ATTACHMENT E – POTENTIALLY ADVERSE SEISMIC CONDITIONS

**Licensing Basis (LB) Evaluation Form**

Seismic Walkdown Submittal Report Review Comments and Resolutions Form			
Engineering Report Number	IP-RPT-12-00039	Rev. 0	Title: Indian Point Energy Center, Unit 3 Seismic Walkdown Report for Resolution of Fukushima Near-Term Task Force Recommendation 2.3: Seismic		
Quality Related: <input type="checkbox"/> Yes <input checked="" type="checkbox"/> No		Special Notes or Instructions: N/A			
Comment Number	Section/Page No.	Review Comment	Response/Resolution	Reviewer's Accept Initials	
	AWC-01, AWC-03, AWC-07, AWC-08, and AWC-12.	SWEL component formatting is not consistent with EN-DC-168. <i>It must be SWEL1-XXX</i> AWC format needs to be AWC-XXX.	SWEL and AWC sheets have been reviewed for consistency with formatting and revised as necessary.	P.P.	
Reviewed By:	Pouria Pourghobadi 	Date	11/14/2012	Resolved By:	Paul Huebsch 
Site/Department:	IPEC/ENERCON	Ph.		Date: 11/14/2012

SWEL1-070

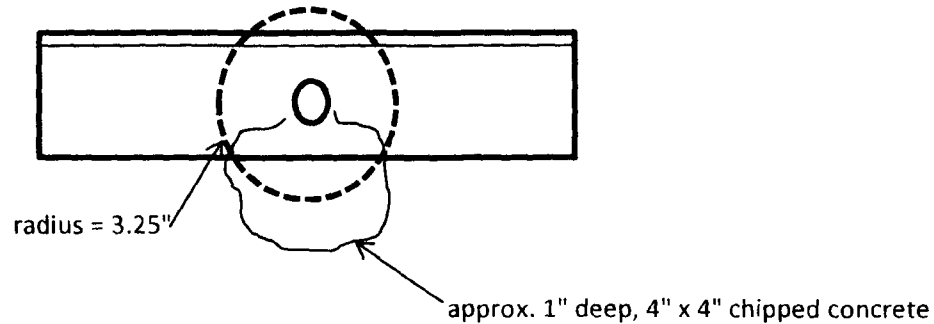
A 1" deep, 4"x4" chip concrete area adjacent to Hilti bolt

The 1" deep concrete chipped area is conservatively treated to cover 35% of the shear cone area for a 3.25" embedment expansion bolt. The 1" deep, chipped area still has capacity and can be considered as 35% of a shear cone area of a (3.25"-1") = 2.25" embedment anchor.

**AWC- 27**

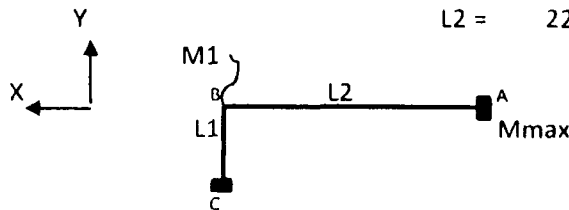
Liquid Waste pipe has 25' to 30' span length

- D = pipe outside diameter = 4.5 inch
- t = wall thickness for sch 40 pipe = 0.237 inch
- S = section modulus of 4" Sch 40 pipe = 3.21 in<sup>3</sup>
- w = uniform weight of pipe and water = 16.3 plf
- P = design pressure = 150 psi
- i =SIF of 4" LR elbow = 1.95

## AWC- 12

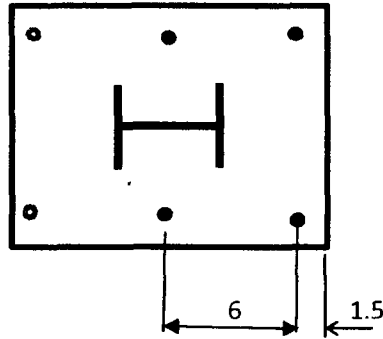
PWR-599 has only 4 anchor bolts instead of 6

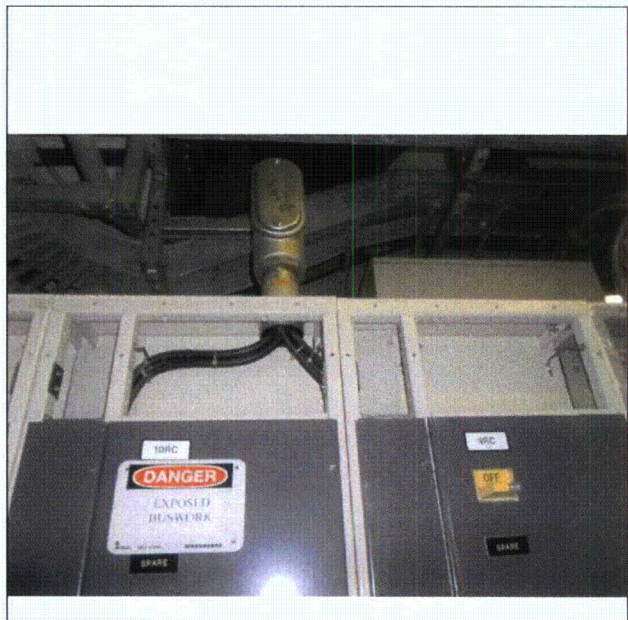
Housekeeping issue  
Fuse left inside the floor space

Housekeeping issue  
Tie wraps left inside the floor space

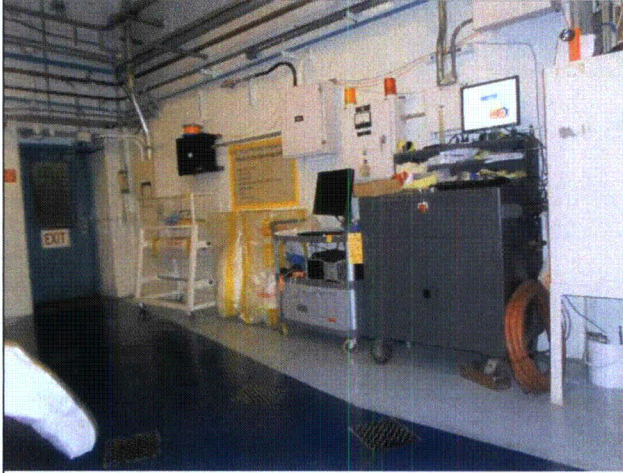
Two carts by HP desks have wheels that are not blocked/choked

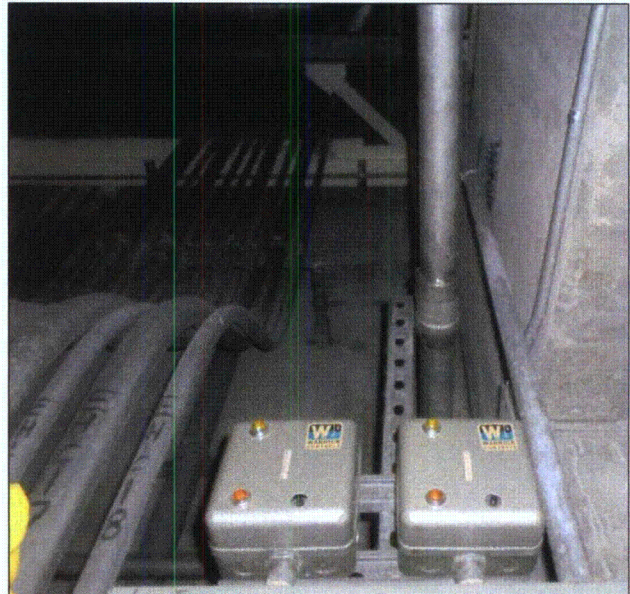
**Conclusion** (8) Condition Meets the Licensing Basis:  Yes  No

Prepared by: Kai Lo  Date 10-26-2012  
Licensing Basis Reviewer

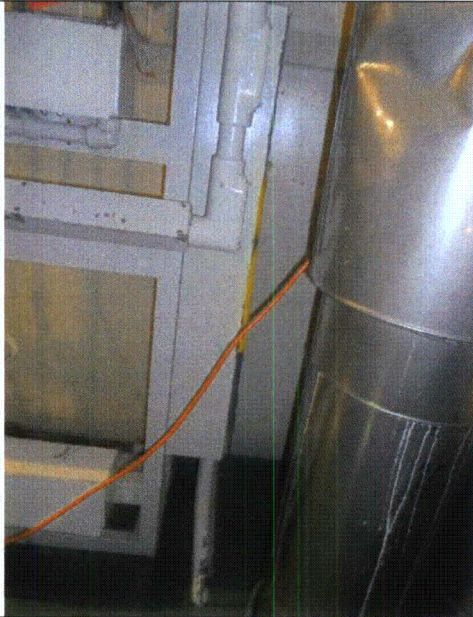
LB Evaluation No. LB-09 Originating SWC/AWC AWC-14

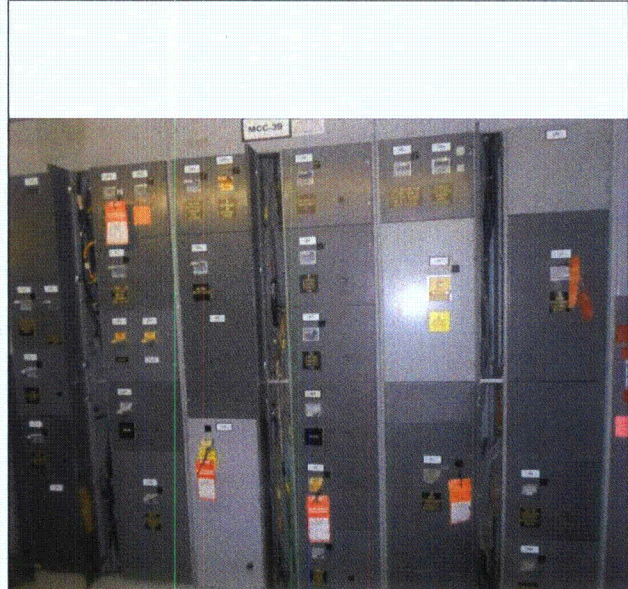
A camera support base plate does not have any anchor bolt. Need to see if the support can overturn during a seismic event.

**Documents Reviewed**

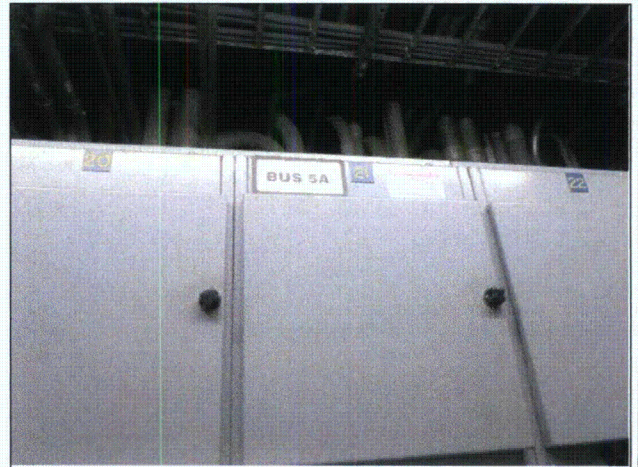
*Missing screws on the panel cover.*
